SUBJECT: Roundtable Technical Working Group September 13, 2018 Overview/Packet

SUBJECT: Possible Work Plan Items and Initial Prioritization Based on 2018 TWG Summaries

SUBJECT: Summary of the 2018 Technical Working Group (TWG) Meetings Regarding the FAA Initiative Document

Figure D5: Graphical Depiction of Routes

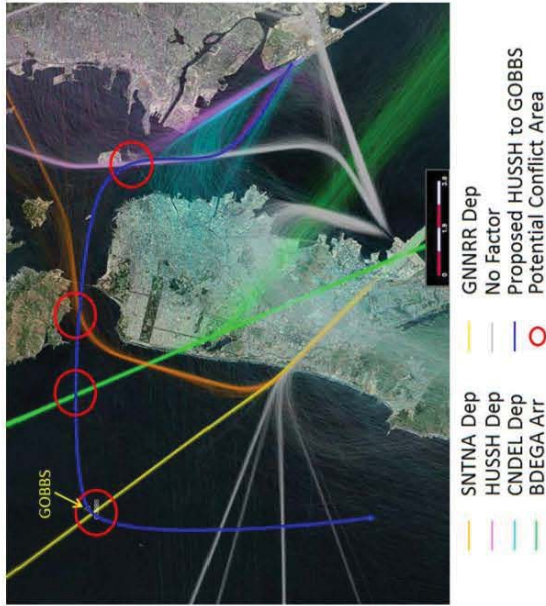
> 25 mile vertical (not horizontal) separation could it address the 4confight areas/red circles below?

2.31 Determine if a revised southbound transition (with additional waypoints) for the CNDEL procedure could "contain" the flight paths further west (GOBBS and south) to allow expanded clear space for possible modification of the SSTIK departure.

AL-375 (FAA)

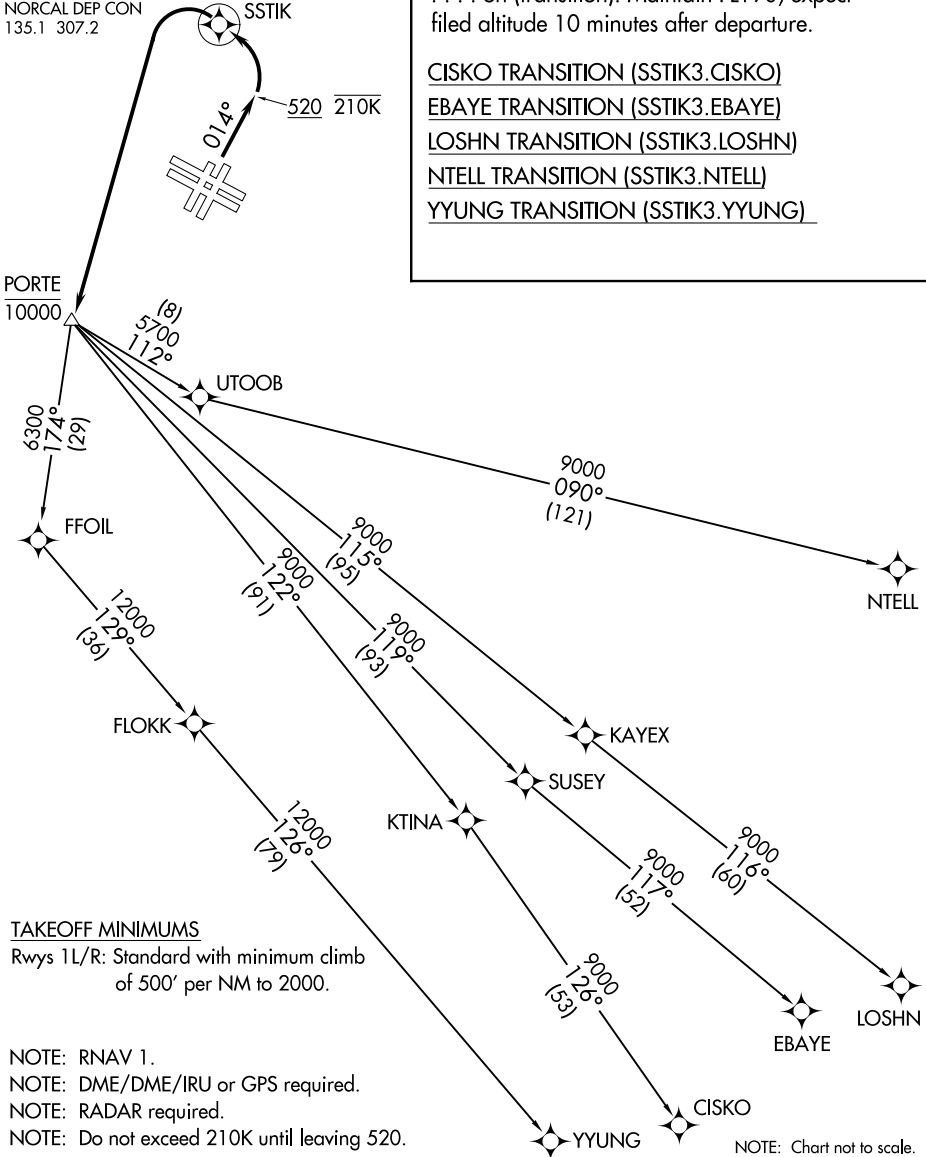
The SSTIK waypoint is located at the southern tip of Brisbane lagoon (<http://opennav.com/waypoint/US/SSTIK>). If planes are supposed to be TURNING through SSTIK as the charted procedure ("left turn direct to SSTIK") indicates (see attached), then the ones that are flying up the bay and turning over our homes are NOT, in fact, on the procedure as charted but are being vectored over us, which might explain why we didn't have this problem when NextGen was first implemented 2 years ago. But now, coincidentally(?) following a RT recommendation to fly planes further up the bay "to gain altitude" (which was very ill advised since the SSTIK departures can't ever fly about 5000ft because that conflicts with the CNDEL departures) this has effectively resulted in nothing more than a "noise shift" to our communities, wherein we find ourselves getting the brunt of the SSTIK departures despite this not being the "charted procedure"

The planes are supposed to be flying on a 014 degree heading following take-off as they make their approach to turn left through SSTIK. I don't know what the "520" refers to in "Climb heading 14 degrees to 520") The reports we have been given at the RT meetings that the majority of the planes are passing through SSTIK is misleading regarding what is actually happening because they are not passing through it as charted in the procedure but are instead just flying due north on a 355-0 degree heading through it (to us). Following take-off, they straighten out and start flying this 355 - 0 degree heading north through SSTIK as opposed to flying the 14 degree heading to a point east of SSTIK and then turning west and south through it.

1. What does "Top Altitude: FL190" mean???
2. To what does the 520 refer in "Climb heading 14 degrees to 520"
3. Confirm whether the routes that are sending planes over our communities are "vectored routes" as opposed to "charted procedure routes".

JO 7110.308: 1.5-Nautical Mile Dependent Approaches to Parallel Runways Spaced Less Than 2,500 Feet Apart

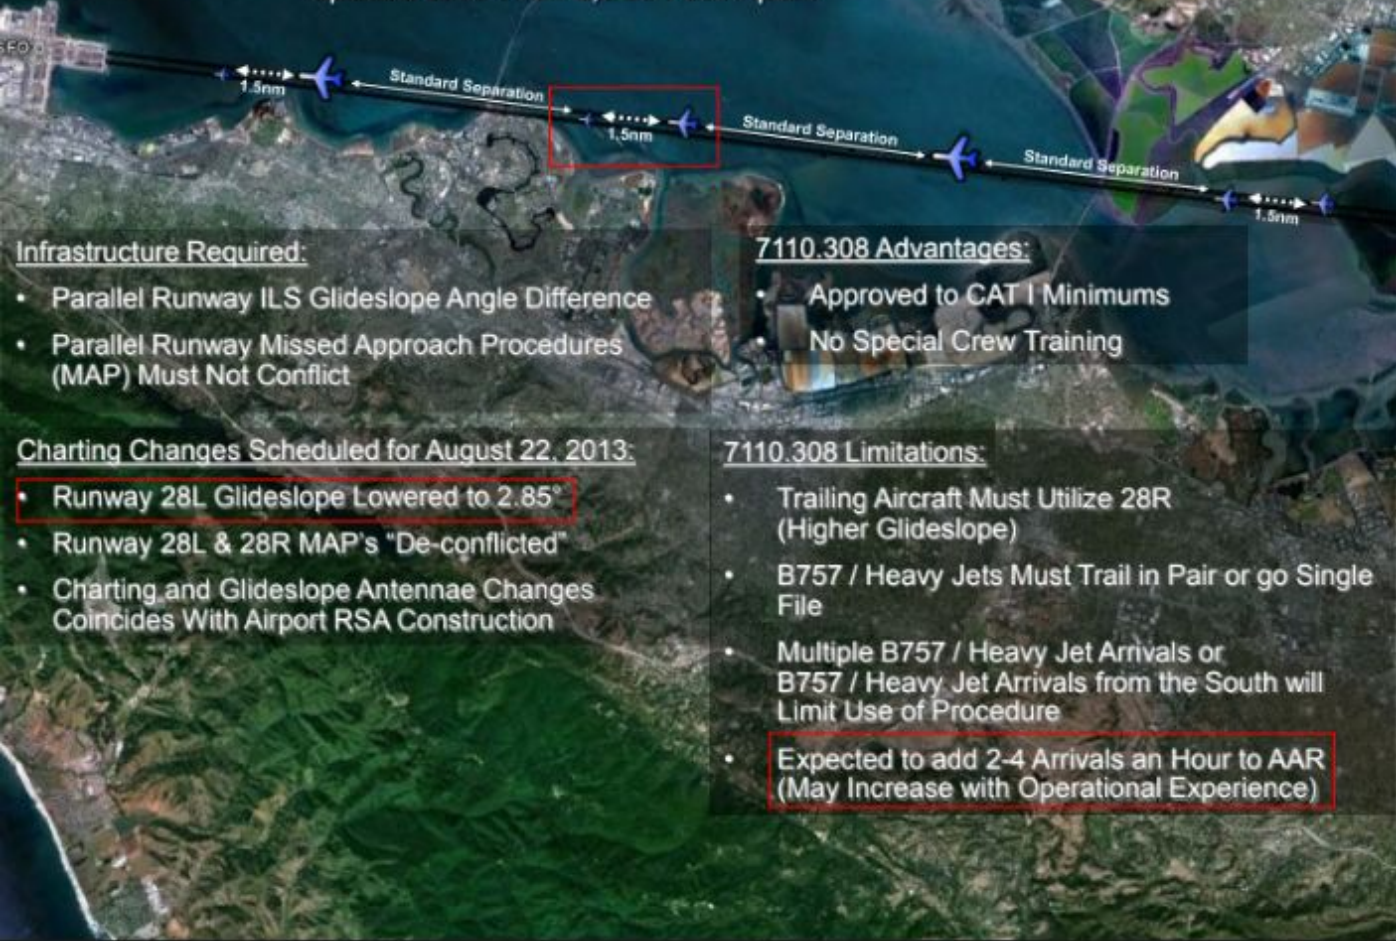
- Lowering the glideslope for runway 28L to 2.85 degrees was a result of FAA order JO 207110.308 that reduced the diagonal separation to 1.5 nautical miles for closely parallel runways (e.g. spaced less than 2,500 feet). The reduced diagonal separation was expected to allow 2 to 4 additional arrivals an hour (and possibly more based on experience) after implementation started August 22, 2013 (see slide below).
- Data analysis by the community shows that the altitude near MENLO is closer to 4,000 ft, not 4,600 ft as stated by the FAA.
